Model type:
WIL105EU

Commercial code:
F030233

1140960 Exploded views

1180160 Exploded views

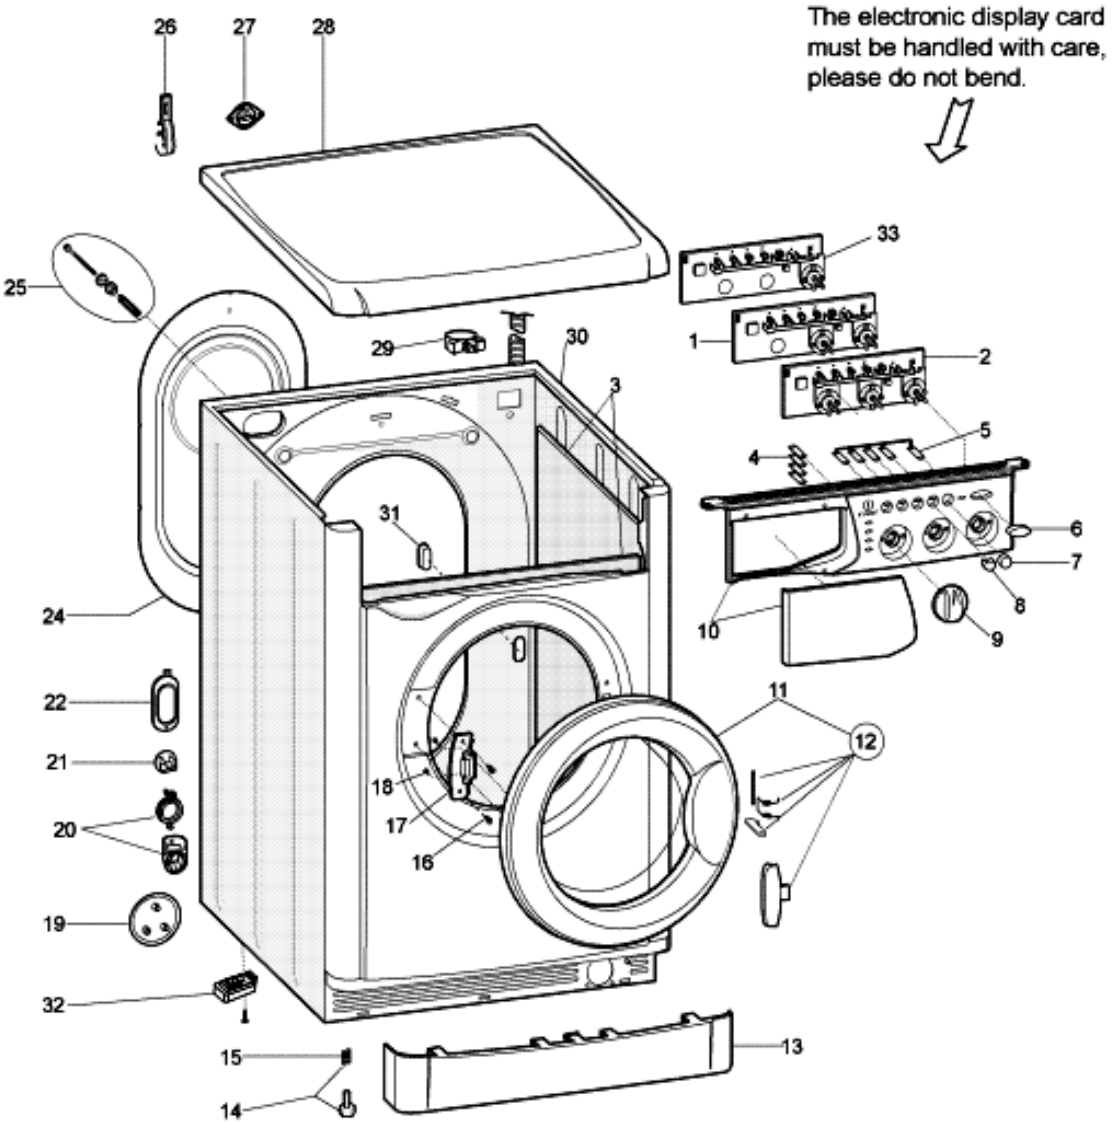
n1040334: INDESIT Led and Digit modules with side connector.

From serial no. 40802.0001, WIL and WISE models produced in the Teverola factory are gradually being equipped with LED and DIGIT modules with connector on the side instead of on the top, near the microprocessor.

The new modules are:
C00143085 - LED MODULE ASSEMBLY 2 KNOBS WITH CONNECTOR EDG IND.EVOII;
C00143332 - LED MODULE ASSEMBLY 3 KNOBS WITH CONNECTOR EDG IND.EVOII;
C00143086 - DIGIT MODULE ASSEMBLY WITH CONNECTOR EDG IND.EVOII.

Premodified modules C00096997, C00096998 and C00096999 will continue to be available until stocks run out, after which they will be interchangeable with the new modules that will be provided with a specific wiring to enable interchangeability (C00114634).

1180250 Exploded views

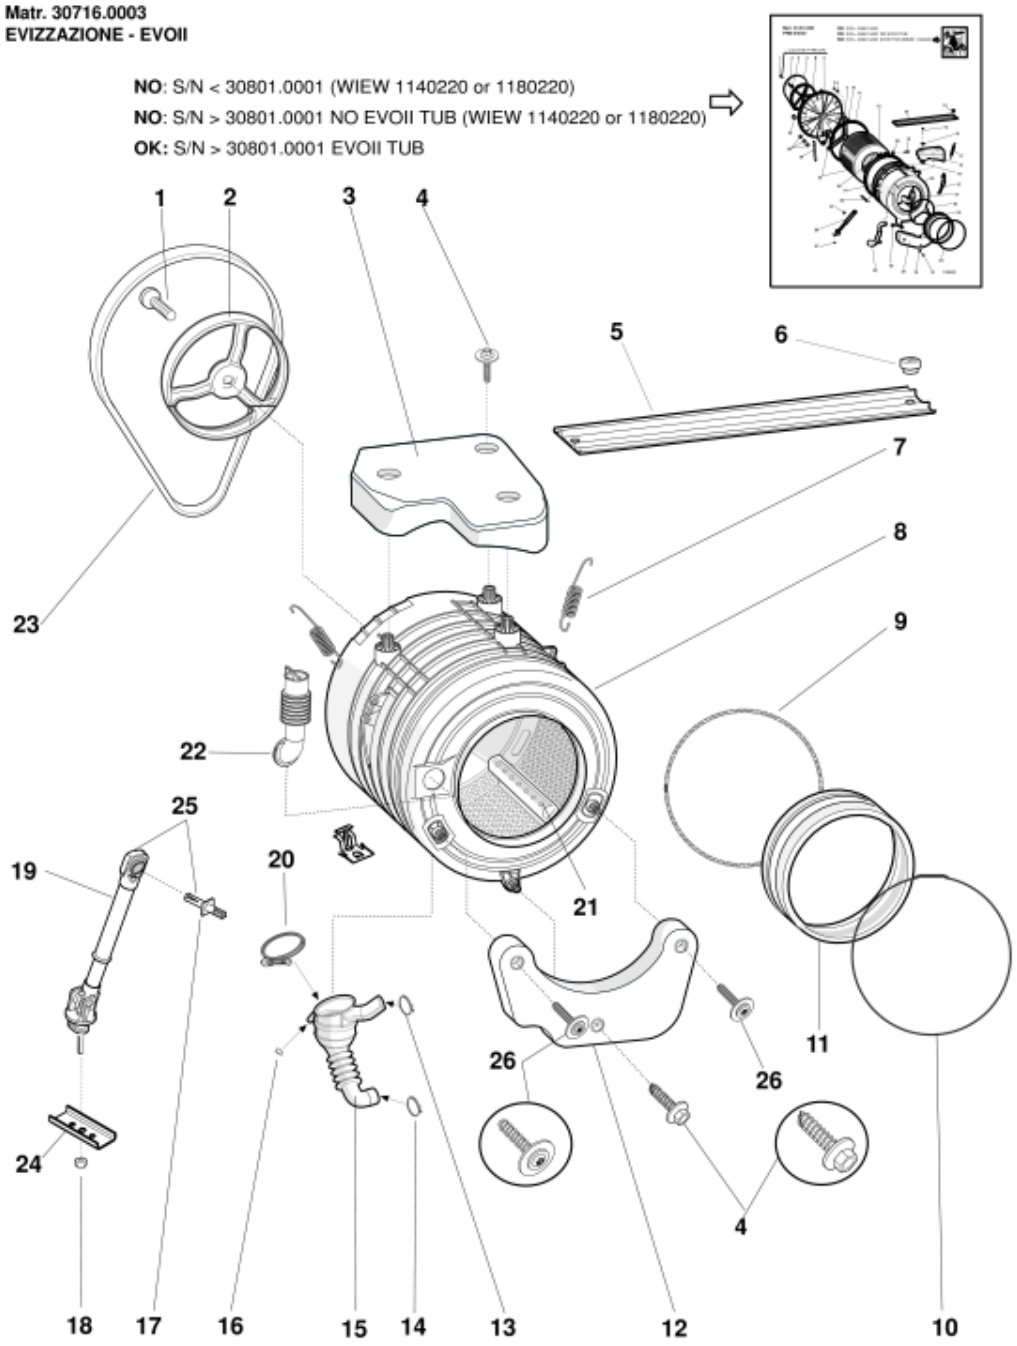
n1040372: Introduction of new shock absorbers and expanders.

From serial no. 50725.0001, new shock absorbers and expanders have been introduced.

New codes:
C00140670 - shock absorber
C00118593 - expander

Premodification codes
C00097259 - shock absorber
C00055037 - expander

The new items can also be used (but not separately) when replacing shock absorber 100N - C00097259; in this case, it will be necessary to replace both shock absorbers / expanders using kit C00140744, which is composed of two new shock absorbers and two new expanders.
